HOWARD COUNTY HISTORIC PRESERVATION COMMISSION

December Agenda

Thursday, December 1, 2016; 6:30 p.m.

16-103 – 8386 Court Avenue, Ellicott City

Figure 10 - Front door

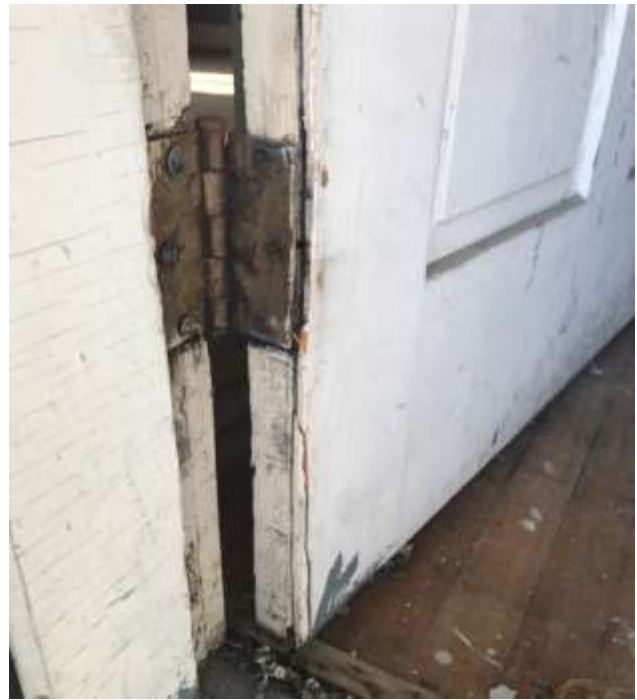
Front doors - The front door does not appear to be damaged beyond repair. It is located under a porch and was covered with a storm door so it should not be in so poor of a condition that repair would not be possible. Staff requested additional photographs showing damage and the Applicant has submitted the photos shown in Figures 10-12 below. Staff recommends denial of replacement front door and recommends the door be repaired and tax credit pre-approval for the work.

- 1) Denial of replacement of the front door and recommends the door be repaired and tax credit pre-approval for the work.
- 2) Approval of the replacement of the side basement door and tax credit pre-approval for the work.
